Contract #: 04-0120F4Cty: SF/ALA Rte: 80 PM: 13.2/13.9File #: 69.25B**QUALITY ASSURANCE -- NON-CONFORMANCE REPORT****Location:** Changxing Island, Shanghai, P.R. China**Report No:** NCR-000724**Prime Contractor:** American Bridge/Fluor Enterprises, a JV**Date:** 30-Apr-2010**Submitting Contractor:** Zhenhua Port Machinery Company, Ltd (ZPMC), Changxing Island**NCR #:** ZPMC-0687**Type of problem:**

**Reference Description:** Improper procedures in welding in 7CW/7DW Side and Bottom Panel without a CWR

**Dear:** Mr. Charles Kanapicki  
**Job Name:** SAS Superstructure

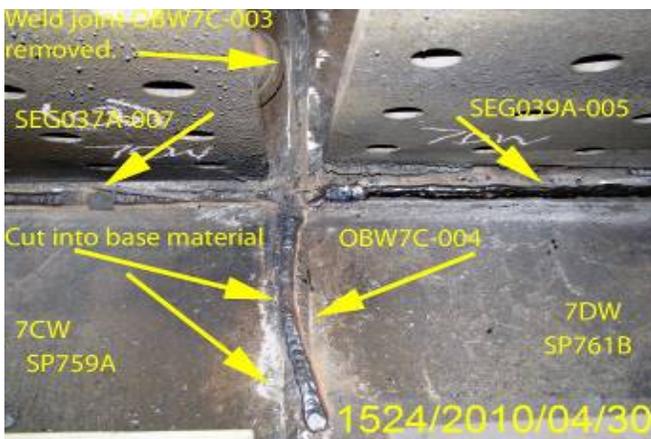
During random in process observation of the Trial Assembly of OBG segment 7CW and 7DW, this Quality Assurance (QA) Inspector discovered the following issues:

- ZPMC welding personnel cut apart weld joints and performed Critical Weld Repair (CWR) welding on Seismic Performance Critical Members (SPCM) without an approved CWR procedure.

- In the welding of joint OBW7C-004, a section of the weld has been unzipped and rewelded. It was noted that the cut and repaired base metal was partially in the base metal of SP761B and BP146A.

- It appeared that the surfaces to be welded had not been properly cleaned, beveled or prepared prior to the weld repairs. The original welds had not been completely removed and the burn slag (dross) was still visible.

- The weld joints that were cut apart to adjust for a misalignment are identified as: SEG037A-007, SEG039A-005, OBW7C-003 and OBW7C-004.
- These weld joints are Complete Joint Penetration (CJP) welds.

Propose a resolution for the identified non-conformance with revised procedures to prevent future occurrences. A response for the resolution of this issue is expected within 7 days.

Reference Description: Improper procedures in welding in 7CW/7DW Side and Bottom Panel without a CWR

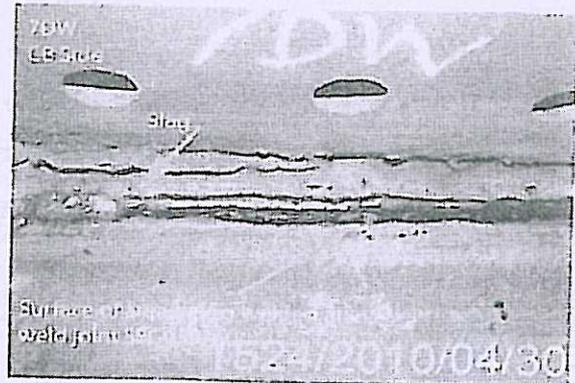
During random in process observation of the Trial Assembly of OBG segment 7CW and 7DW, this Quality Assurance (QA) Inspector discovered the following issues:

- ZPMC welding personnel cut apart weld joints and performed Critical Weld Repair (CWR) welding on Seismic Performance Critical Members (SPCM) without an approved CWR procedure.

- In the welding of joint OBW7C-004, a section of the weld has been unzipped and rewelded. It was noted that the cut and repaired base metal was partially in the base metal of SP761B and BP146A.

- It appeared that the surfaces to be welded had not been properly cleaned, beveled or prepared prior to the weld repairs. The original welds had not been completely removed and the burn slag (dross) was still visible.

- The weld joints that were cut apart to adjust for a misalignment are identified as: SEG037A-007, SEG039A-005, OBW7C-003 and OBW7C-004.
- These weld joints are Complete Joint Penetration (CJP) welds.

#### Description of welding discontinuity:

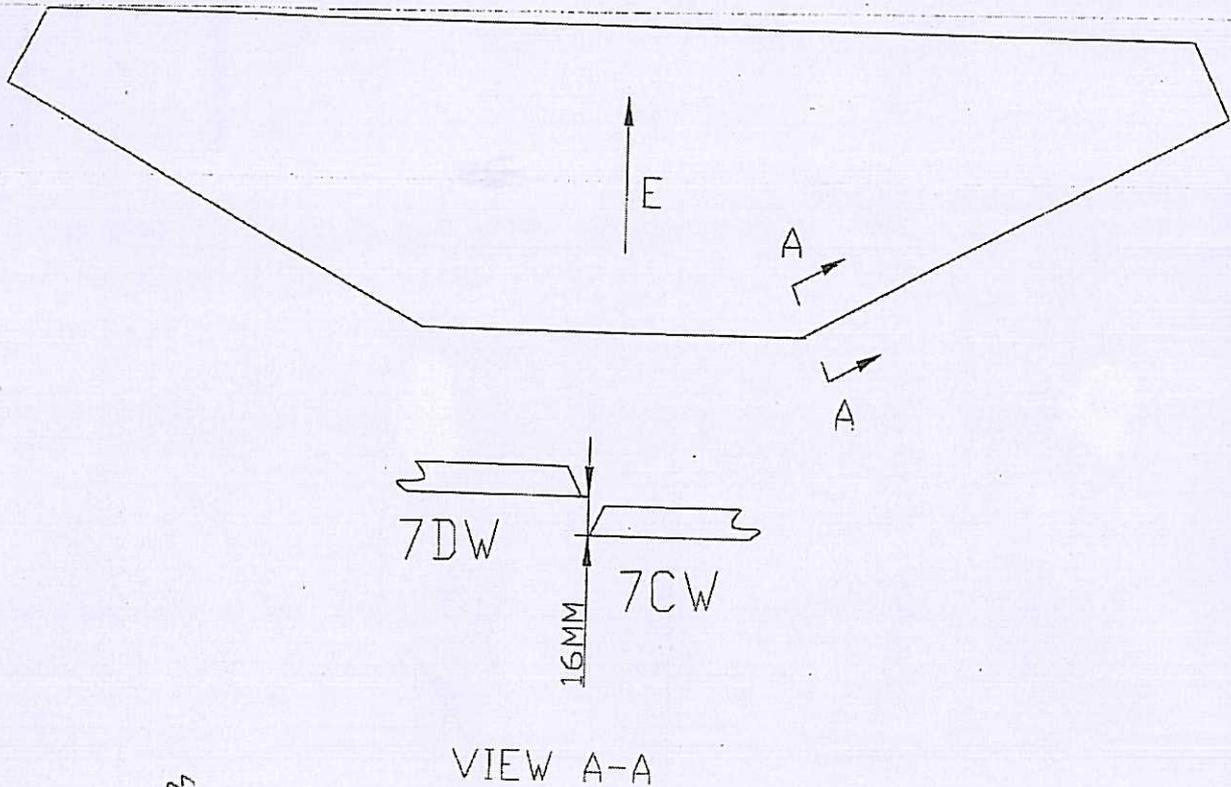
7CW+7DW端口环缝, T肋对接焊接结束后, 测量联系梁侧底板斜底板拐角的错边量, 发现数据超标, 最大达16mm。  
(可能涉及的焊缝OBW7C-004, SEG037A-007, SEG039A-005; SP759-001-044, SP759-001-054)

After T ribs on 7DW and 7CW were butted together, it was found that corners between bottom plate and side plate have misalignments, the largest of which is 16mm in length.

1. 采用碳刨或火焰切割的方法割除平整度超差位置纵桁与底板的角度焊缝长度L, 后割开相应位置的斜底板与底板拐角处的主焊缝(注: L、L'切割长度可根据现场实际平整度超差情况进行确定), 碳刨前应根据相应的WPS进行预热;
2. 采用外力调整对接错边量以满足公差要求, 并固定住底板与斜底板以保证平面度满足公差要求;
3. 对底板母材刨除区域进行VT与MT检测确认无缺陷存在;
4. 根据批准的返修WPS焊接底板与斜底板焊缝, 并随时检测底板与斜底板平整度, 其次焊接纵桁与箱梁底板焊缝;
5. 焊接前纵桁底板边缘若损伤需根据返修WPS进行修补并做相应的NDT检测;
6. 将焊缝打磨与周边焊缝或母材平齐;
7. 根据图纸要求进行检测。

1. Remove the welds where the straightness is out of tolerance between LD and bottom plate by the way of gouging or Oxygen, then the weld between side plate and bottom plate with length of L (The L, L' length is confirm by actual condition), Preheat according to the WPS prior to gouging.

2. Adjust the misalignment and the straightness to meet the tolerance by outer force and ensure the straightness to meet the tolerance.
3. Perform 100%VT and MT inspection to the metal cutting area in the bottom plate to ensure no defects exist;

4. Fit up and weld LD the weld between side plate and bottom plate according to the relevant WPS with check the flatness sometime, and then weld the welding line between LD and side plate;

5. Repair and perform related NDT inspection according to the repair WPS if the edge of LD was destroyed.
6. Grind the weld flush to the adjacent weld or base metal.

7. Check the weld according to the shop drawings.
